09/391,294 09/07/99 WILSON

Application Number: 09/391294
Filing Date: 09/07/1999
Appellant(s): Wilson et al.

EXAMINER'S ANSWER

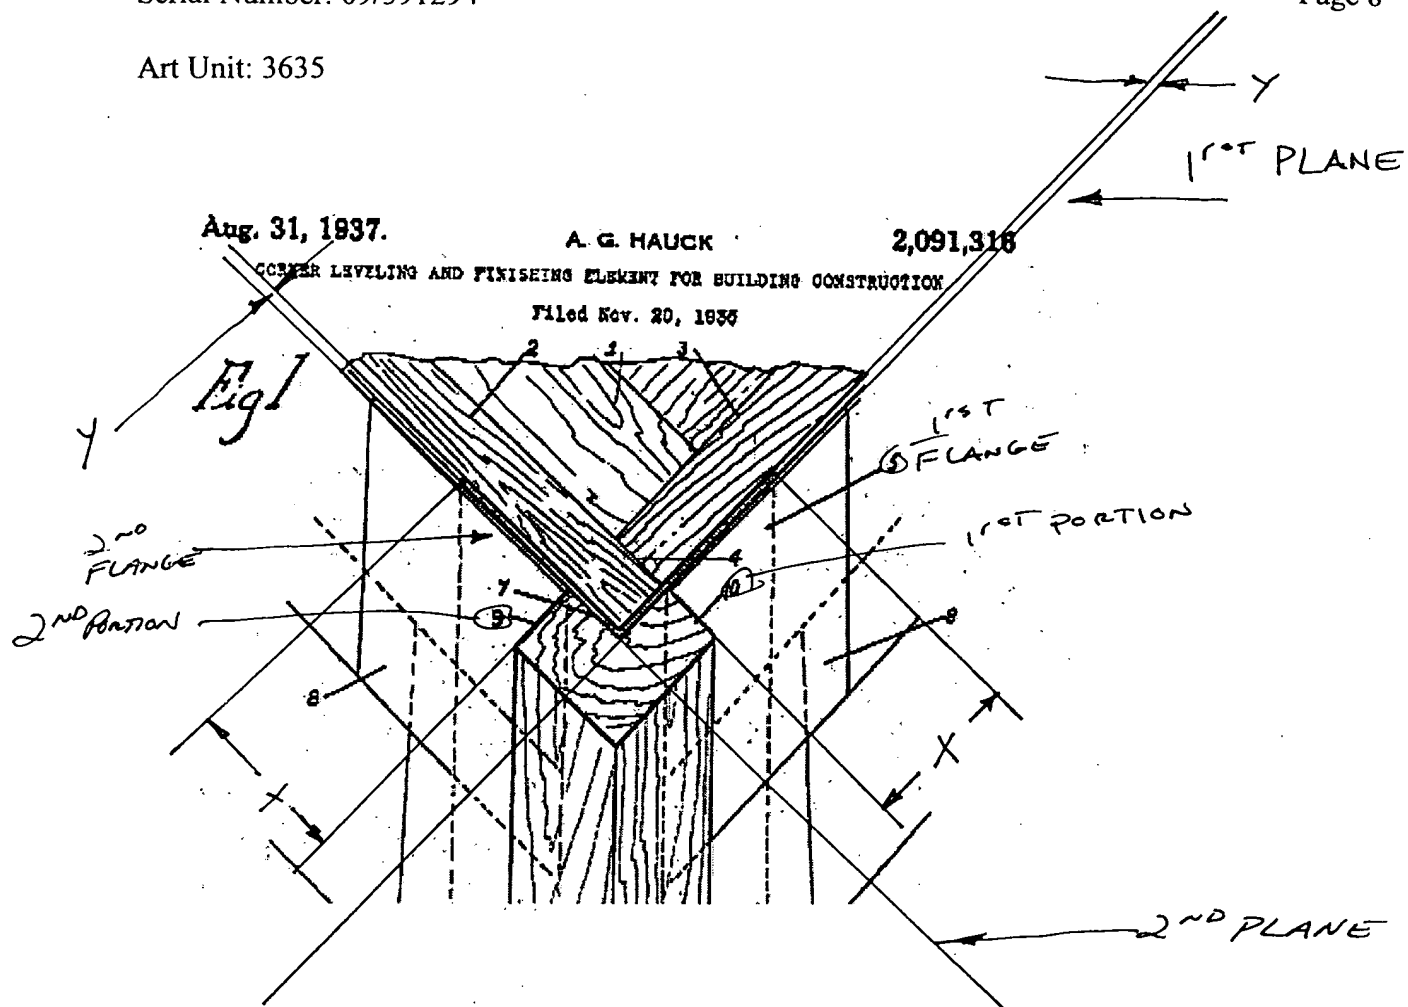
Hauck provides in figure 2 a member 6 having first and second longitudinally extending portions defining a cornered inner surface each having a radially outwardly extending flange 5. The claims are considered to be drawn to the member alone not in combination with a building and corner post. The wood 6 is a material having insulating qualities.

Applicant argues that the flanges of Hauck do not extend from the portions. It is the examiner's position that the flanges can be interpreted to extend from the portions in the directions X and/or Y in the marked up figure below.
